TEXAS UTILITIES ELECTRIC COMPANY, ET AL.*
COMANCHE PEAK STEAM ELECTRIC STATION, UNIT 1
DOCKET NO. 50-445
AMENDMENT TO FACILITY OPERATING LICENSE

Amendment No. 4
License No. NPF-87

ATTACHMENT TO LICENSE AMENDMENT NO. 4

FIGURE 3.4-4. PORV SETPOINTS FOR OVERPRESSURE MITIGATION APPLICABLE UP TO 16 EFPY

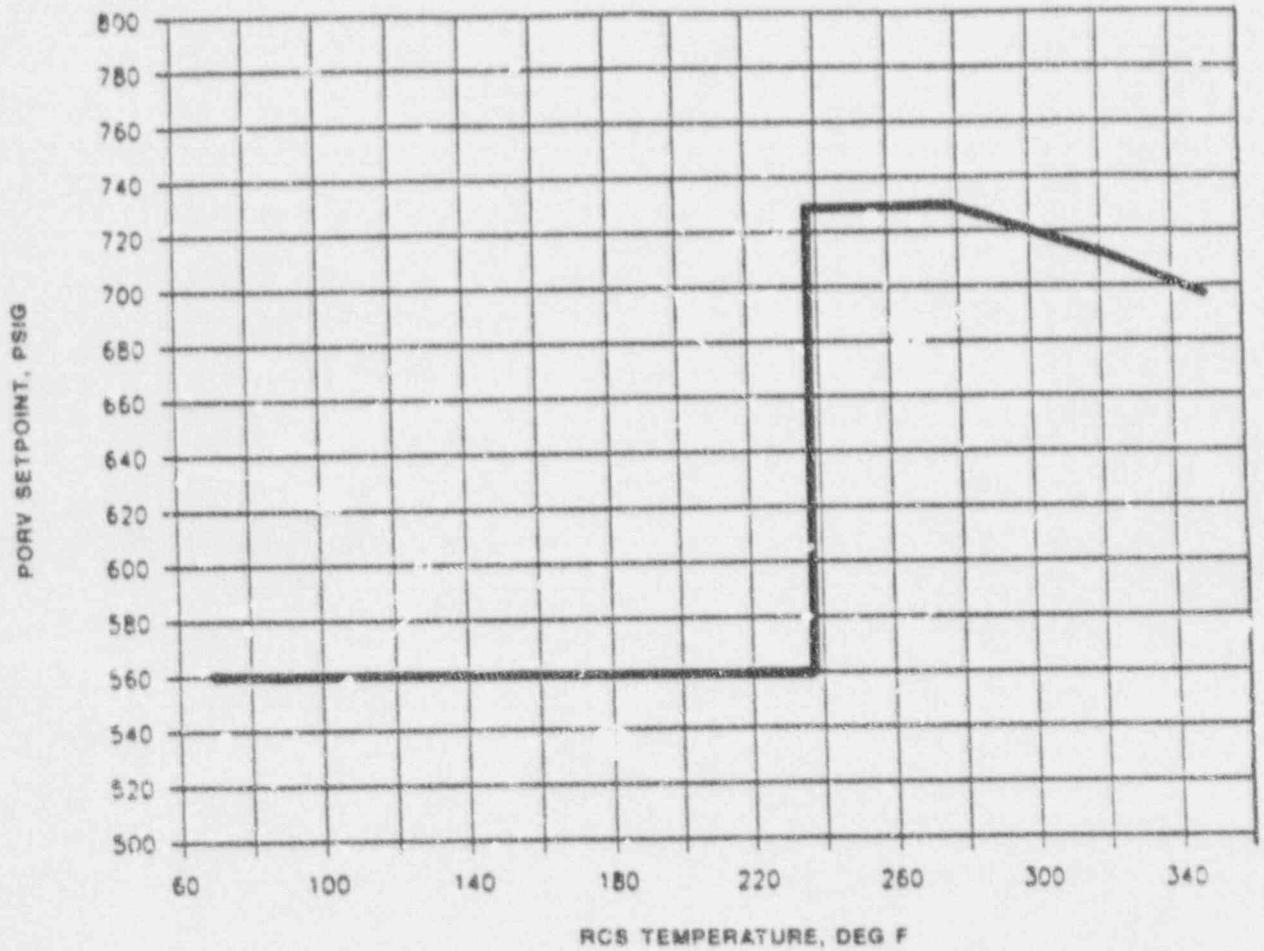
Revise Appendix A Technical Specifications by removing the pages identified below and inserting the enclosed pages. The revised pages are identified by amendment number and contain marginal lines indicating the area of change. The corresponding overleaf pages are also provided to maintain document completeness.
